# Ngaio cycleway audit - safety and accessibility

90% design audit

This CASA is for the 90% design stage of Wellington Transitional Cycleways, Ngaio Gorge section.

**Figure 2-16: Proposed traffic calming on Crofton Road**

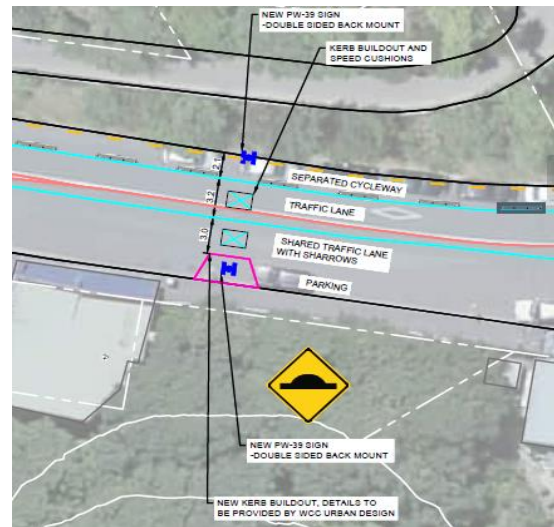
The 30% audit mentioned extending the 30 km/h speed limit from Ngaio village; from this recommendation the location has been moved back to the Crofton Road shops. This is favourable but the CAT believes speed cushions should be installed to assist with the speed change.

The pedestrian crossing being installed on Ngaio Gorge Road has speed cushions on both approaches but the existing Crofton Road pedestrian crossing only has one; to be consistent and help with the speed limit change it is recommended to install speed cushions on both.

2.15.1 Provide physical traffic calming at the Kenya Street speed limit change

**Designer** Traffic cushions were not proposed for this section due to the narrow two-way traffic lane width of 5.5m.

As described in the response to Finding 2.14 feedback received for the 90% design has recommended that the speed cushions are changed to speed humps.

<p>Providing an additional hump in this location was highlighted in the feedback, and addresses positioning issues with the speed cushions.</p> <p>On this basis a speed hump will be added in this location addressing the CAT recommendation.</p>
<b>Safety Engineer</b>	Agree with Designer.
<b>Client</b>	Agree with designer.
<b>Action</b>	Add speed hump.

Figure 2-17: Collingwood Road proposed speed limit change location and treatment

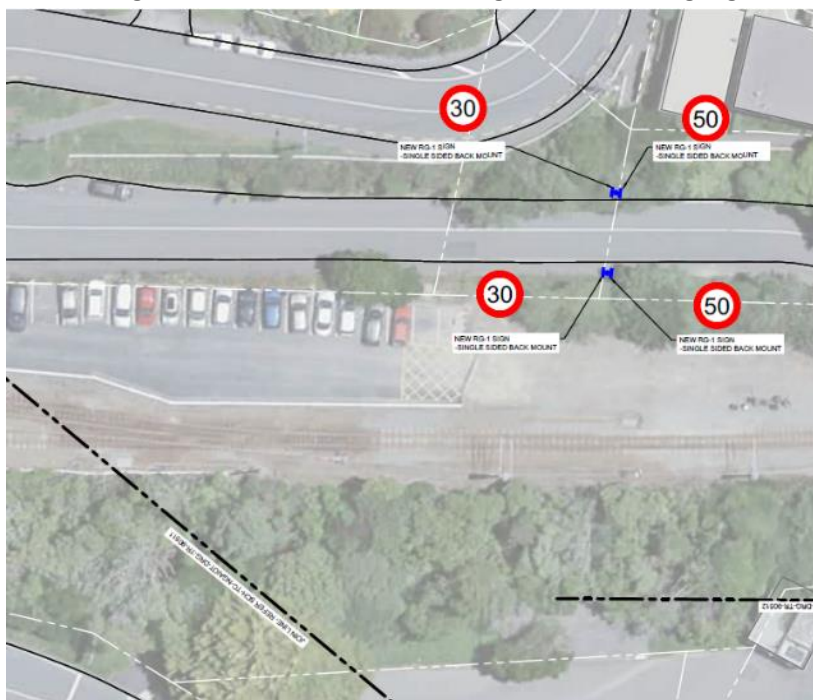
Figure 2-17 shows the location of Collingwood Street speed reduction; the CAT ponders if the speed change should occur after the entry into the train station.

No red road marking is included on side roads, the CAT ponders with the speed reduction in these areas that red road marking should be used on each change location to highlight the change in speed.

2.16.1	Investigate moving location of speed change along Collingwood Road
2.16.2	Use of road marking to be consistent through locations of speed limit changes

<b>Designer</b>	<p>2.16.1 The speed change has been located at the first point from the roundabout with sufficient sight distance. Extending the 30km/hr speed area beyond the extent of the proposed cycle facility is beyond the current project scope.</p> <p>2.16.2 Road markings are used to supplement the speed change on the Principal Roads. For local roads only signs have been shown, this aligns with the treatment for Awarua Street and Colway Street at the north end of Ngaio Village.</p>
<b>Safety Engineer</b>	Agree with Designer.
<b>Client</b>	Agree with designer.
<b>Action</b>	No change to plans.
